DUANE ARNOLD ENERGY CENTER

Amendment No. 88  
License No. DPR-49

ATTACHMENT TO LICENSE AMENDMENT NO. 88

SAFETY EVALUATION BY THE OFFICE OF NUCLEAR REACTOR REGULATION

DUANE ARNOLD ENERGY CENTER  
IOWA ELECTRIC LIGHT AND POWER COMPANY  
TECHNICAL SPECIFICATIONS  
LIMITING AVERAGE PLANAR LINEAR HEAT  
GENERATION RATE AS A FUNCTION OF PLANAR  
AVERAGE EXPOSURE  
FUEL TYPE: P8DRB299  
FIGURE 3.12-8

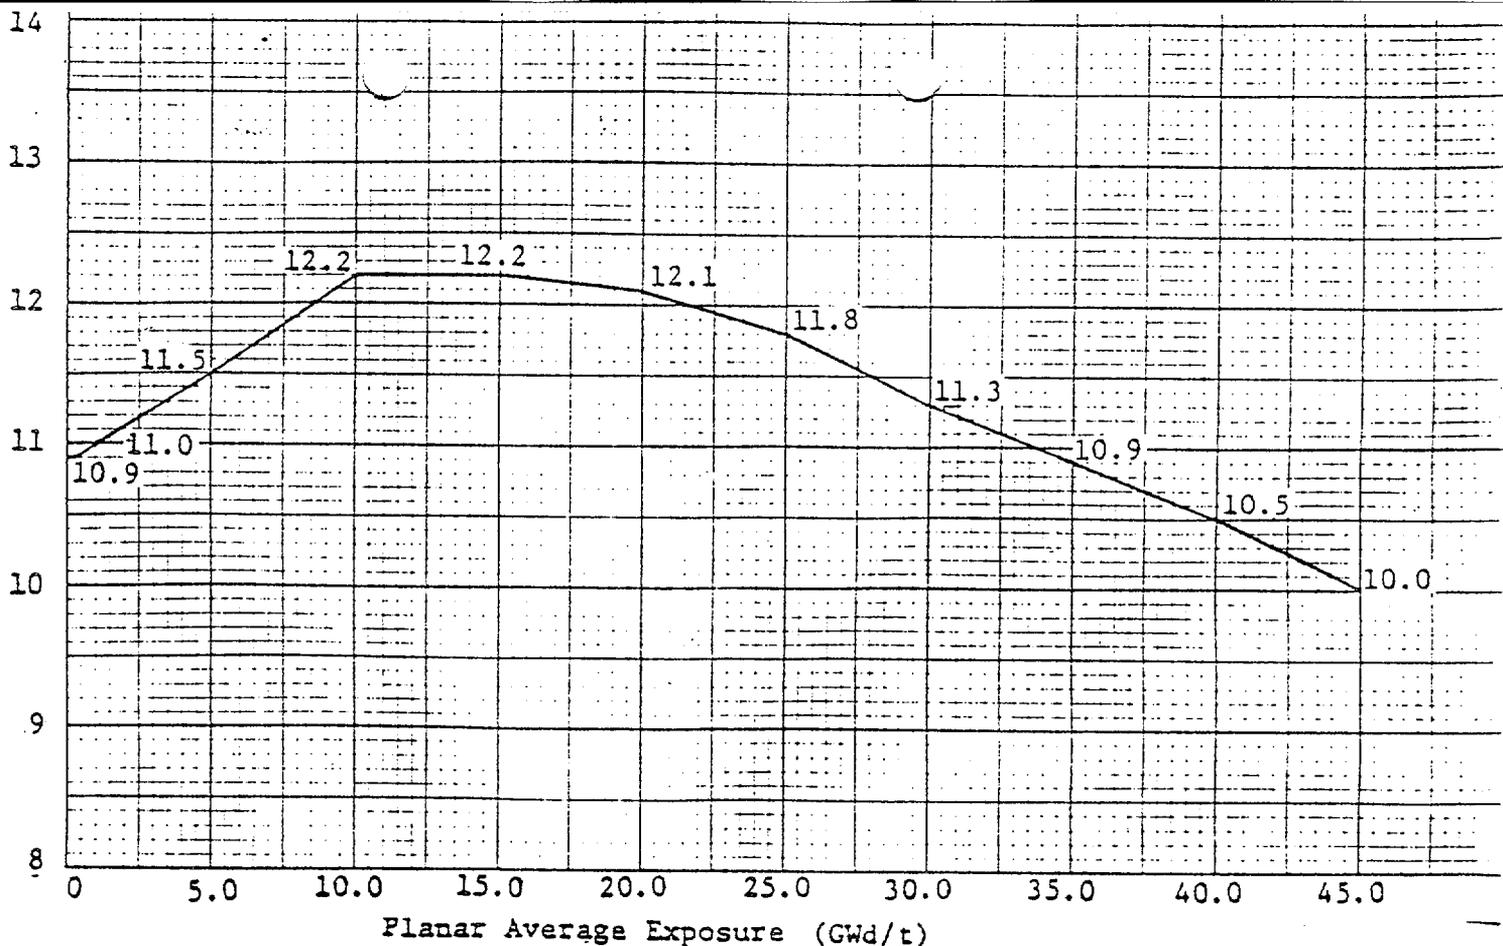
This amendment revises the Technical Specifications to incorporate the limiting conditions for operation during fuel cycle 7 by (1) adding the Maximum Axial Planar Linear Heat Generation Rate (MAPLHGR) operating limits based on the General Electric (GE) analysis for the two new bundle types (P8DRB299 & P8DRB284H) added to the core, and (2) changing Minimum Critical Power Ratio (MCPR) operating limits, based on the GE analysis for both 8x8 and P8X8R fuel types.

During reactor power operation, the actual MAPLHGR for each type of fuel as a function of average planar exposure shall not exceed the limiting value shown in Figs. 3.12-5, -6, -7, -8 and -9. If at any time during reactor power operation it is determined by normal surveillance that the limiting value for MAPLHGR (LAPLHGR) is being exceeded, action shall then be initiated within 15 minutes to restore operation to within the prescribed limits. If the MAPLHGR (LAPLHGR) is not returned to within the prescribed limits within 2 hours, reduce reactor power to  $< 25\%$  of Rated Thermal Power within the next 4 hours. Surveillance and corresponding action shall continue until the prescribed limits are again being met.

1/ When core flow is equal to or less than 70% of rated, the MAPLHGR shall not exceed 95% of the limiting values shown.
